RE: REVIEW OF SUNSET DEVELOPMENT SUBMITTAL

Subject: Sunset – Preliminary Plat

Subject: Sunset Preliminary Plat Submittal and Technical Review

**SUNSET
PRELIMINARY PLAT
SITE PLAN/PHASING PLAN**

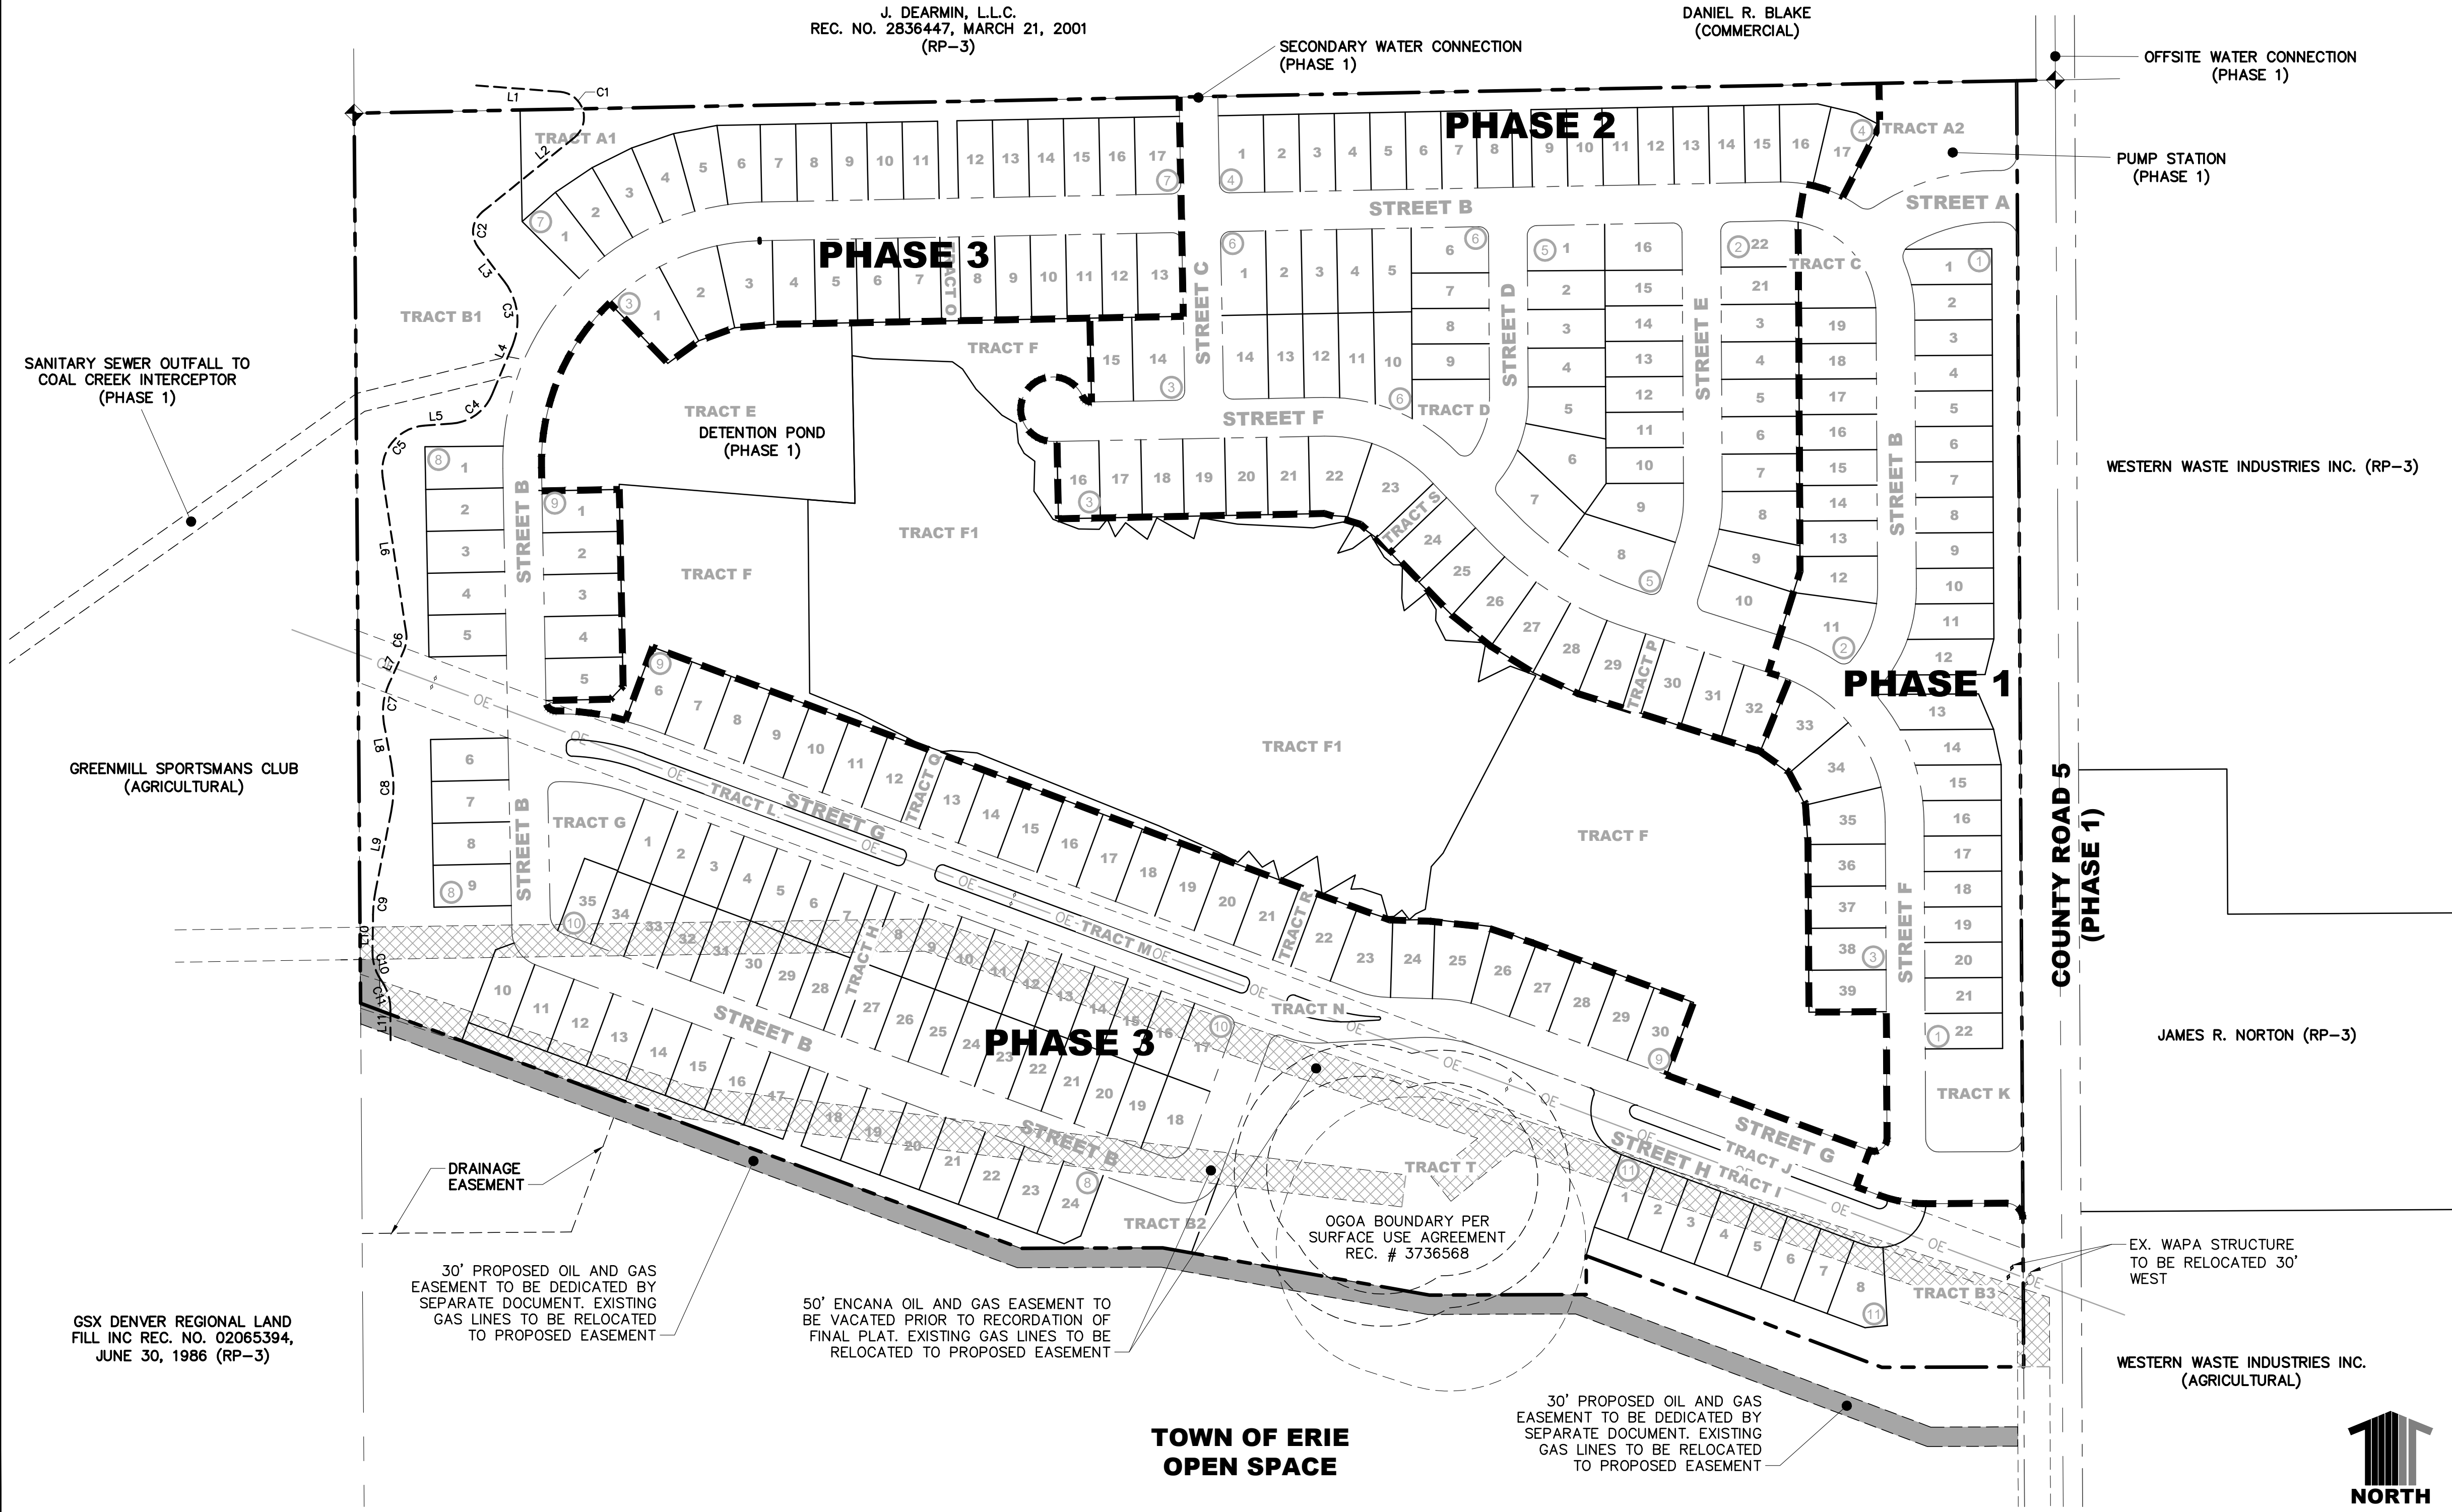
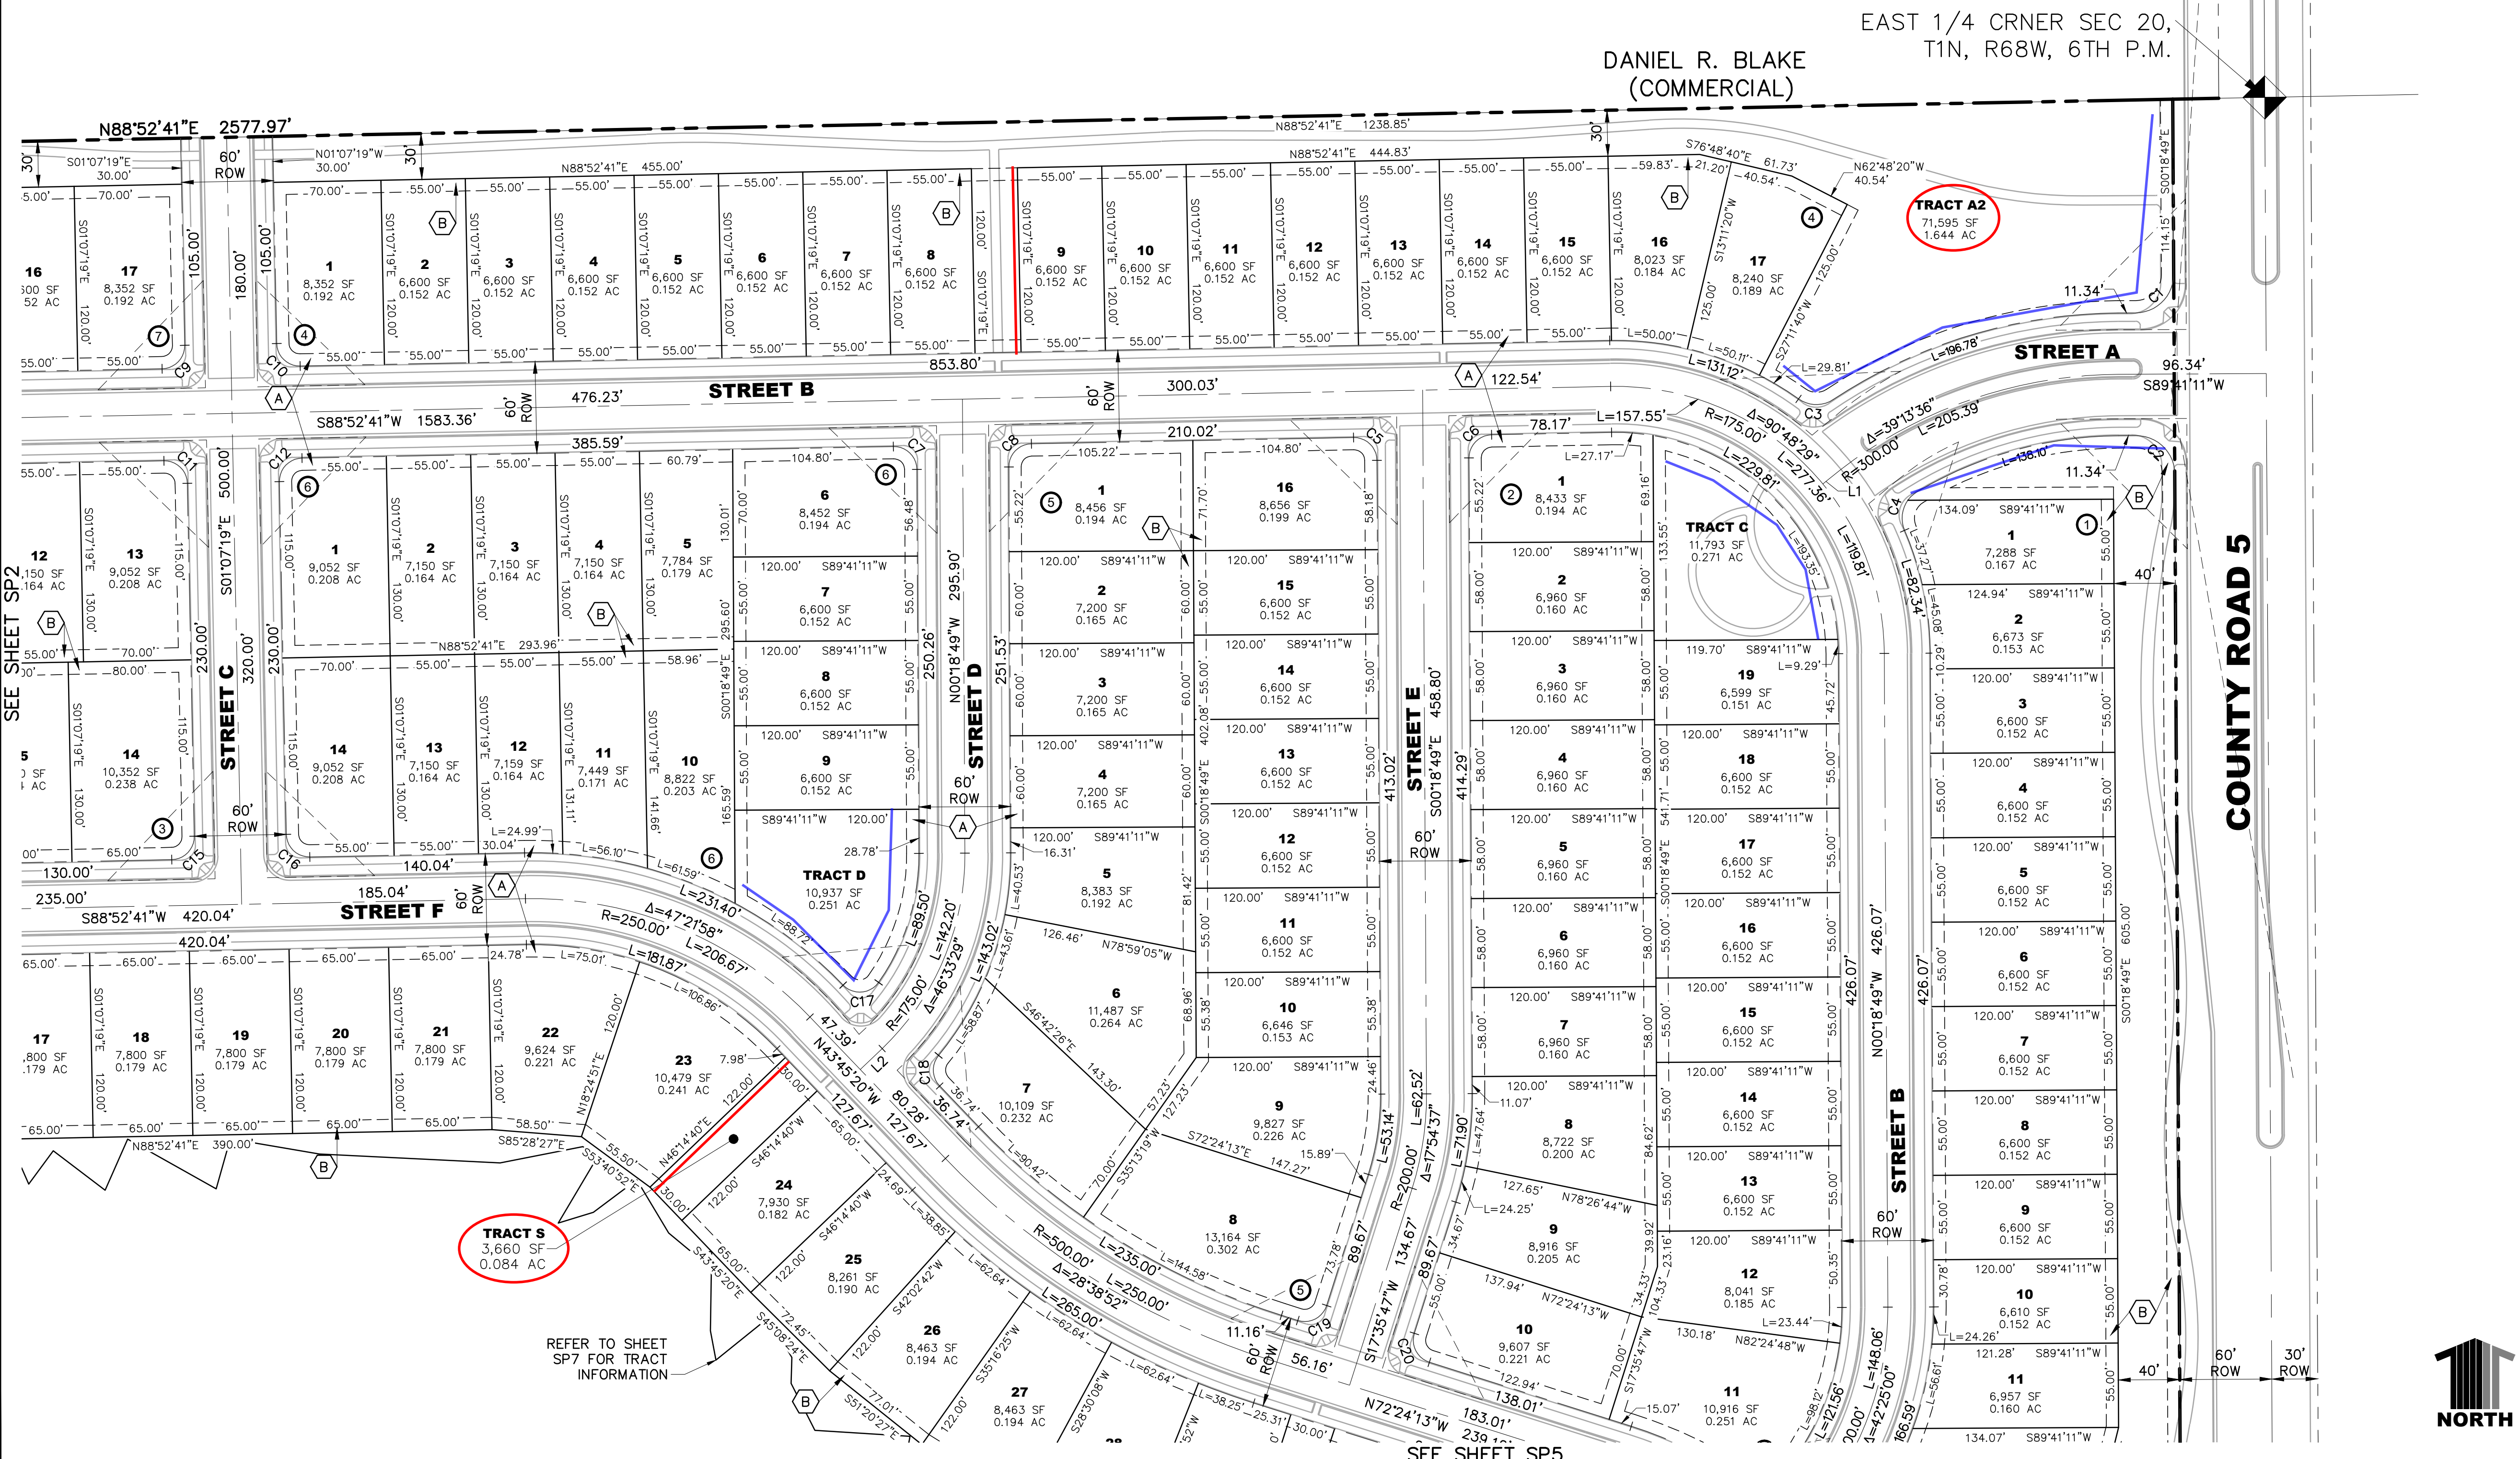
3. Sheet SP1- Site Plan/Phasing Plan
 - a. Update to reflect all previous comments.
 - b. Phases 1 and 2 should be combined into one phase so that a development with appropriate amenities and connectivity is developed. The timing of the construction of the Spine Trail and second portion of the east-west trail along the north property line shall be a specific timeframe specified in the development agreement.

Sheet	4
SP3	of 16
Date	APRIL 26, 2018

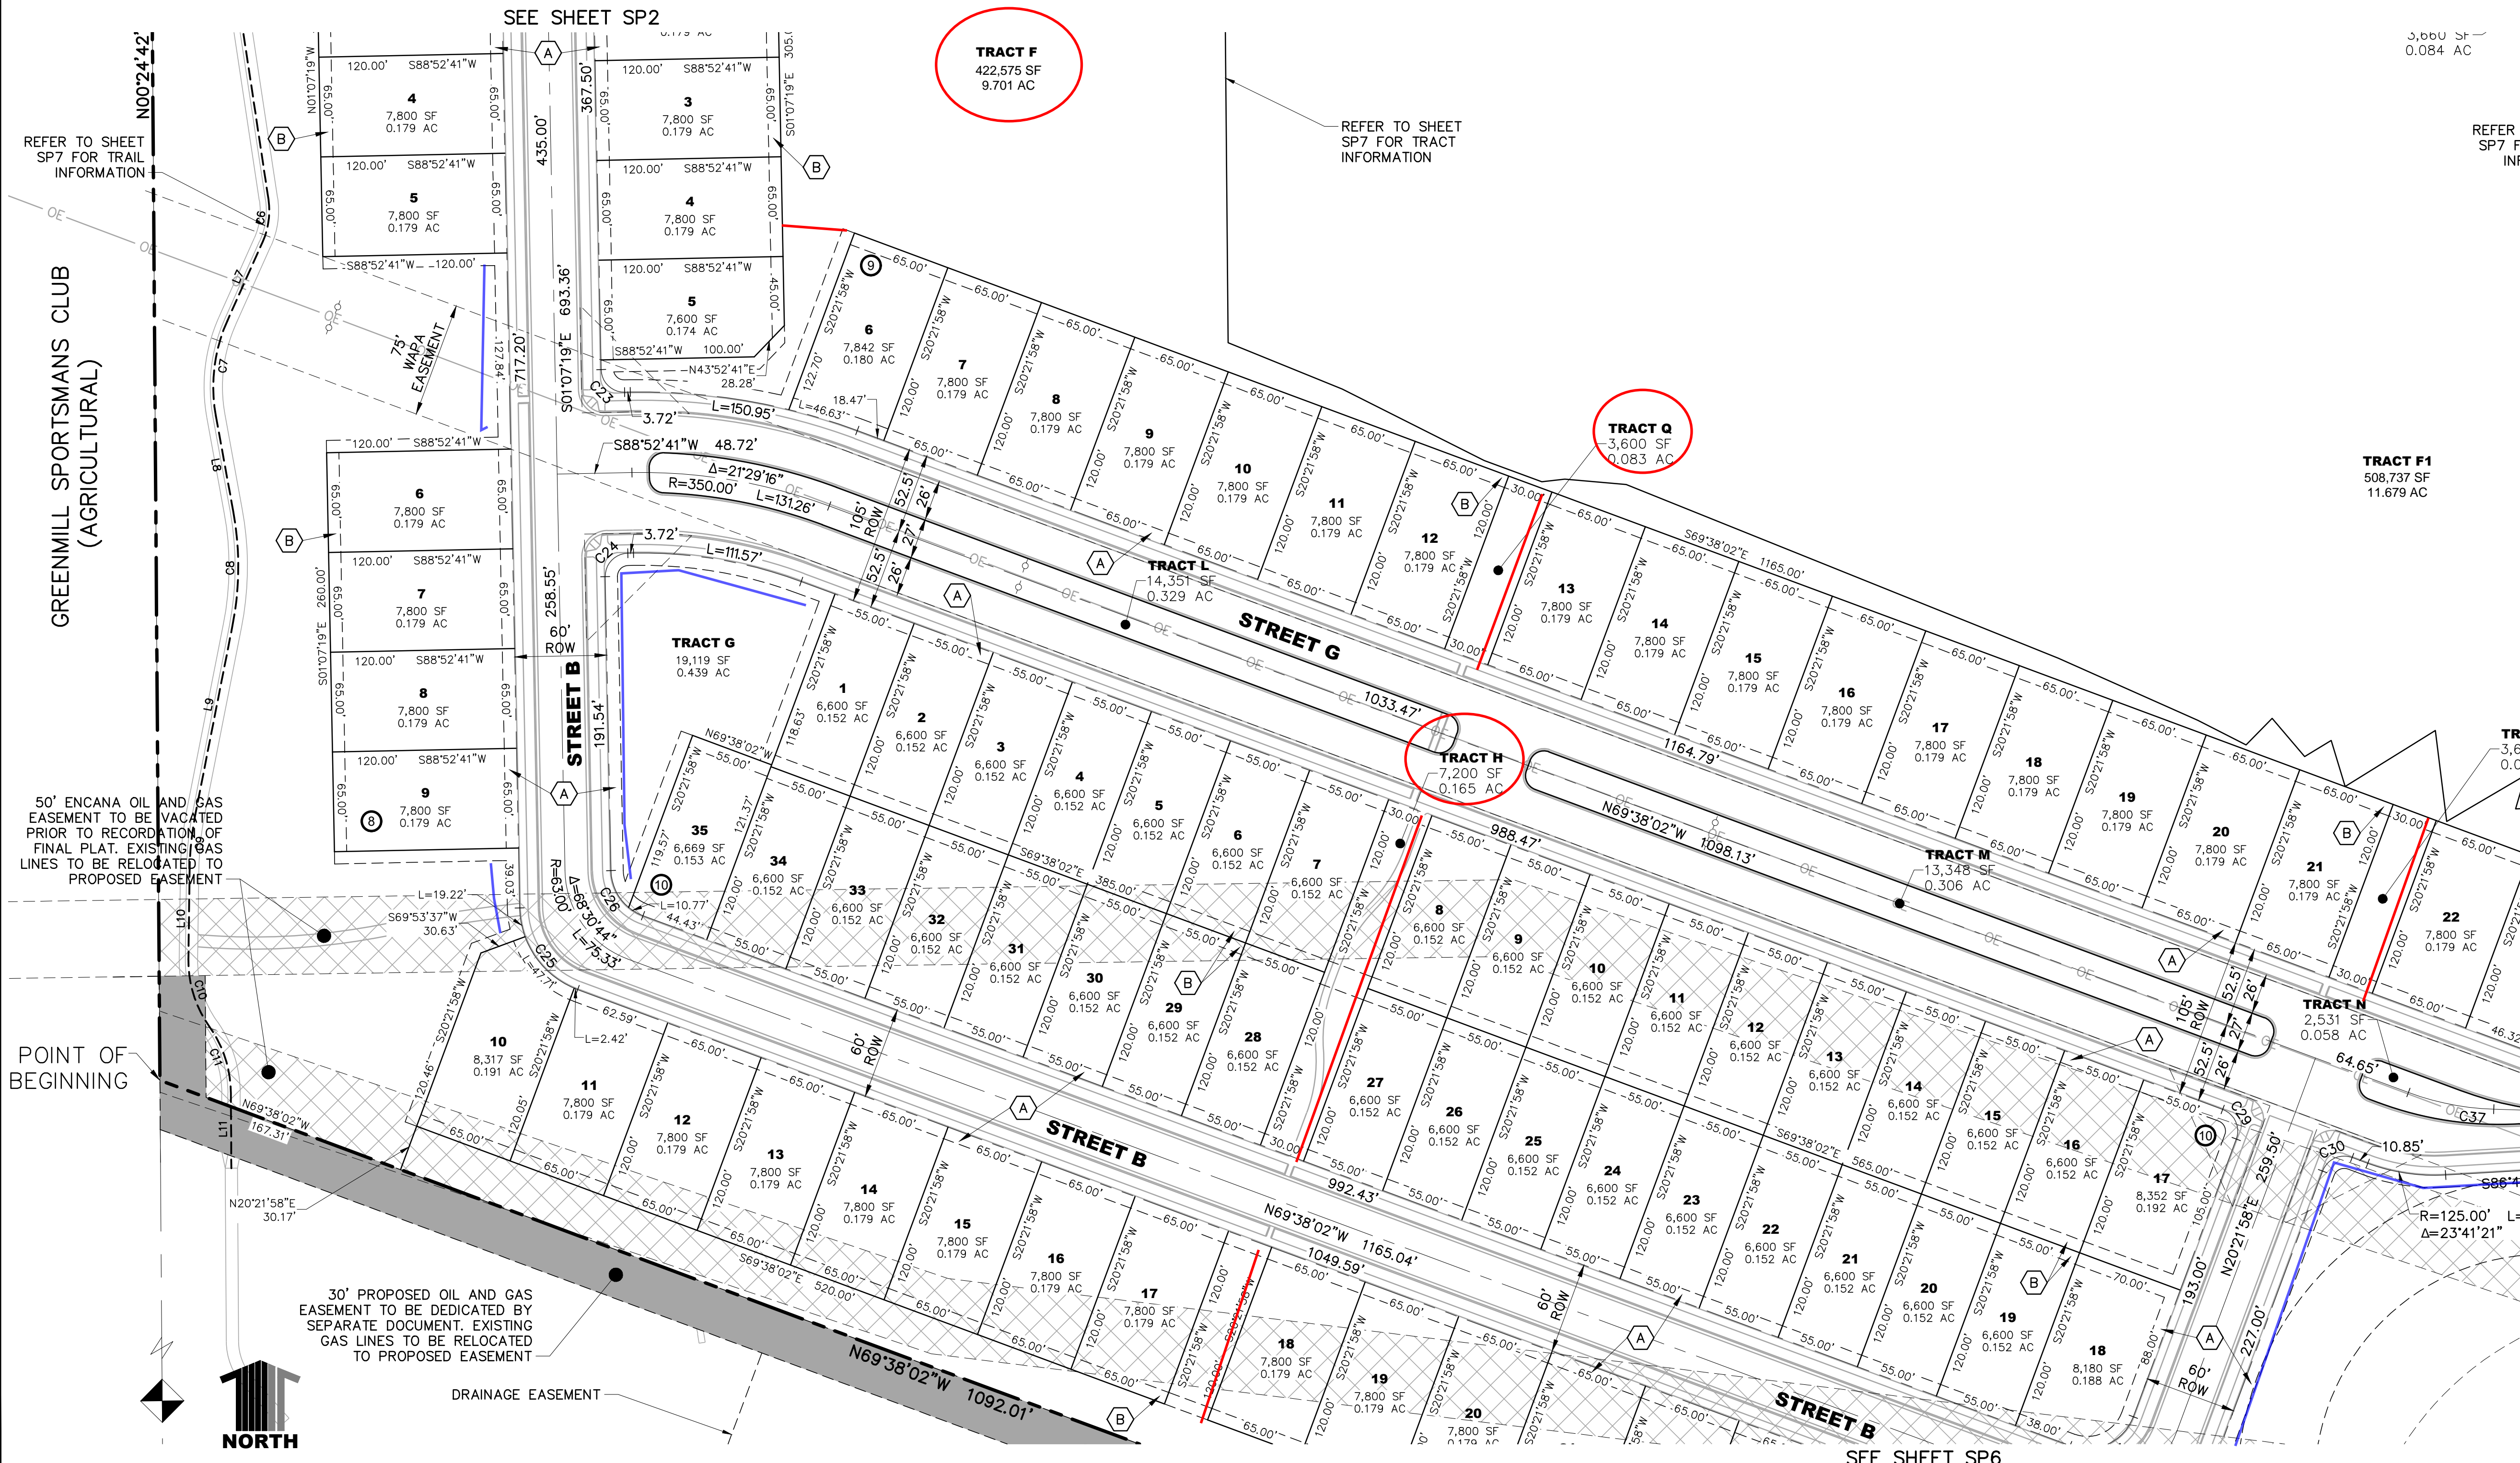
5. Sheet SP3 – Site Plan
 - a. Update as necessary to reflect all previous comments.
 6. Sheet SP4 – Site Plan
 - a. The 30 foot wide tracts located between Lots 21 and 22 and Lots 12 and 13 should not be part of Tract F, these should be a separate tract owned and maintained by the HOA.
